Suburban Infiniti Façade Renovations JC13-99

Consideration of the request of Infiniti of Novi, Suburban Collection for Preliminary Site Plan and Section 9 Façade Waiver. The subject property is located in Section 24 at 24355 Haggerty Road on the west side of Haggerty Road, south of Grand River Avenue in the B-3, General Business District. The applicant is proposing to update all facades of the existing building.

PLAN REVIEW CENTER REPORT

Re: **FACADE ORDINANCE – Final Site Plan Review**
Suburban Infinity, PSP13-0140
 Façade Region: 1, Zoning District: B-3, Building Size: 16,000 S.F.

ELEVATION

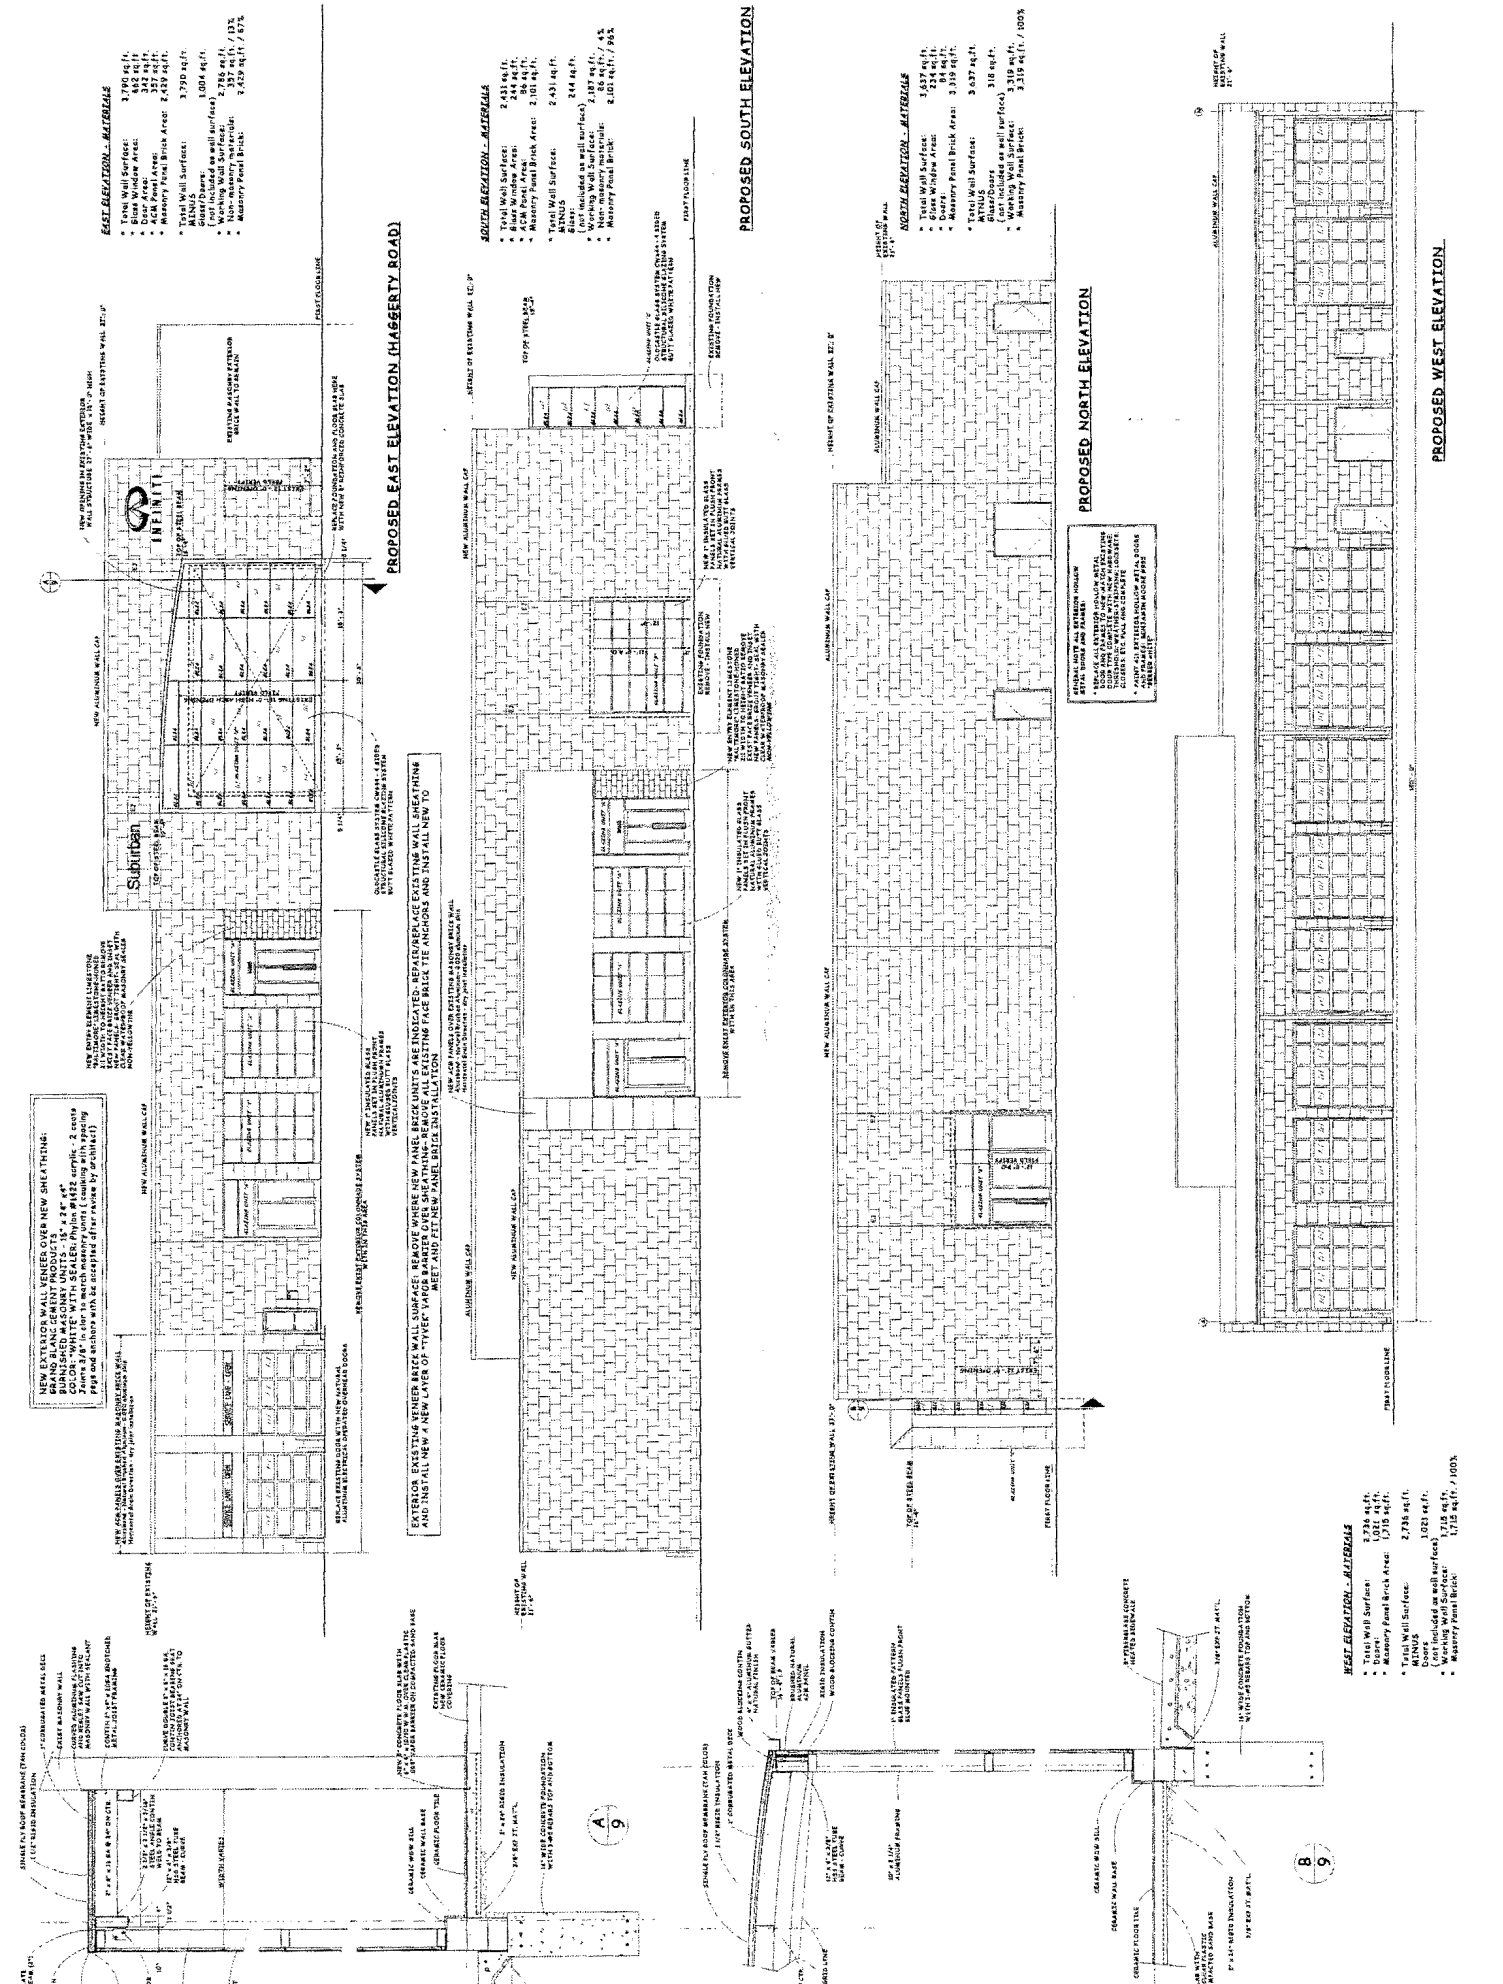
As shown above the minimum percentage of Brick is not provided on all facades and excessive percentages of Burnished Concrete Masonry Units (CMU) are proposed on all façades. A Section 9 Waiver would be required for these deviations from the Façade Ordinance.

The architect has specified a unique type of Burnished CMU that due to its size, texture, and color will have a visual appearance similar to limestone panels. Samples of this material and the Flat Metal Panels have been provided. Limestone is allowed up to 50% by the Façade Chart, as compared to 10% for CMU. However, the proposed percentages of Burnished CMU significantly exceed 50% all facades. In the case of the front (east) and south façades the area of Burnished CMU is adequately delineated by windows, doors and other materials. However, on the north façade a large expanse of Burnished CMU occurs. Considering that the north façade is highly visible from Haggerty Rd. we believe additional articulation of this façade is warranted. We would suggest that integration of additional features and/or materials consistent with the east facade be considered.

The drawings do not clearly indicate the material proposed for upper portions of the south and west facades. On the south façade this area is highly visible from Haggerty Road. It is recommended that this area receive materials consistent with the adjacent wall (Burnished CMU). Also, the material proposed for the existing roof equipment screens is not clearly indicated on the drawings.

Recommendation – It is recommended that the applicant provide additional articulation of the north façade and clearly identify the materials to be used on the unspecified areas of the south and west façades and on the roof equipment screens. We believe that with adequate attention to these comparatively minor items the proposed design will be consistent with the intent and purpose of the Façade Ordinance and may then qualify for a Section 9 Waiver.

1. In the attached drawing of the building exterior, as requested, we have delineated those areas of existing building walls and equipment screens that were not indicated in the original package.
2. The upper wall of the South Elevation is at present existing EIFS surface. We are leaving this wall EIFS due the fact there is no structural elements in this area to support the weight of a masonry material. We will repair the surface of this area and paint/seal to match the new panel brick masonry color.
3. We have reviewed the North Elevation as requested, which is totally face brick. The new panel brick will cover the same area. BUT as requested we have provided additional articulation, by the addition of 4 shadow windows in this area to break-up the wall surface.
